### 3. Operational Safety Verification - Unit 2

7. Independent Inspection Effort - Unit 2

a. Auxiliary Feedwater System Vibration Problem

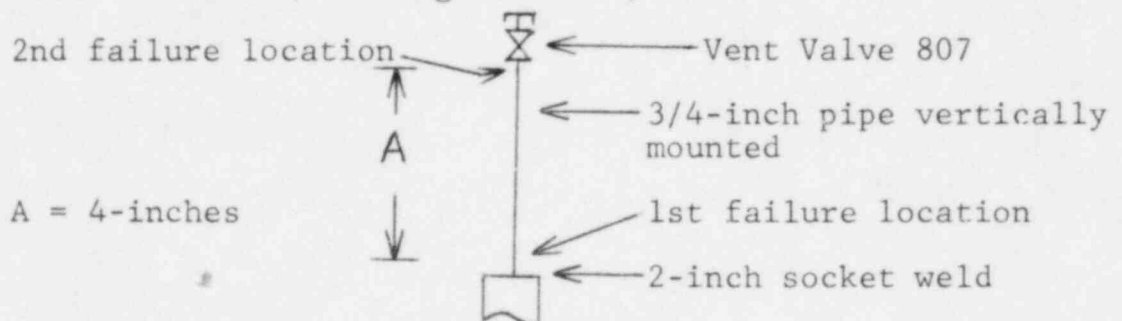
On May 27, 1982 the inspector observed mechanical vibration on the main feedwater line to steam generator 089. The licensee subsequently determined that the observed vibrations resulted from an unauthorized lineup of the auxiliary feedwater system. The unauthorized lineup caused reverse flow through Kerotest valve 154. This valve has a floating disc which vibrated at approximately 3Hz when subjected to reverse flow. This vibration was transmitted through the auxiliary feedwater system to the main feedwater piping.

- (1) Fatigue failure on June 11, 1982, of an ASME code class 3-3/4 inch pipe in the weld heat affected zone above a 2-inch socket weld on the auxiliary feedwater cross-connect piping located in the auxiliary feedwater building. This failure occurred during the vibration testing on June 11, 1982 at 12:45 P. M. No indications of improper welding were identified.
- (2) Fatigue failure, on June 17, 1982 of an ASME Code Class 3-3/4 inch pipe in the weld heat affected zone below a 3/4-inch socket weld to vent valve 807. This failure location was about 4-inches above the first failure (see diagram below).

The failure on June 17, 1982 occurred during feeding of a steam generator using an authorized auxiliary feedwater lineup which did not include backflow through Kerotest valves. This lineup resulted in essentially normal system vibration even though two pipe supports (see (4), below) had been slightly damaged during the initially observed vibration. The licensee's engineering analysis subsequently determined that the degradation of these two supports resulted in a slight increase in vibration of the piping during normal lineups. However, the slight increase in normal system vibration was felt, by the licensee, to have a small effect on the time interval between the first failure on June 11 and the second failure on June 17, 1982. (Again no indication of improper welding existed in this case)

- (3) The reverse flow conditions caused the failure of Kerotest valve 154 such that the valve would pass flow in either direction even when shut manually. The failure of the valve was postulated to have occurred during the initial excessive vibration event.
- (4) Damage indications existed on two supports located on the auxiliary feedwater cross-connect piping. These indications were indentified on June 11, 1982 after the performance of the second vibration test.
- (5) Licensee engineering analysis of the above events concluded, on June 24, 1982, that two separate sections of 2-inch auxiliary feedwater cross connect piping should be replaced due to potential for vibration induced work hardening of the piping material.

The licensee has repaired the above damages and has concluded that the system design margins are restored. To preclude the future possibility of the errant lineup the licensee is considering the addition of a caution statement to procedure SO23-2-4 "Auxiliary Feedwater System Operations" to assure that reverse flow through these Kerotest valves is prevented. (50-361/82-25-01)
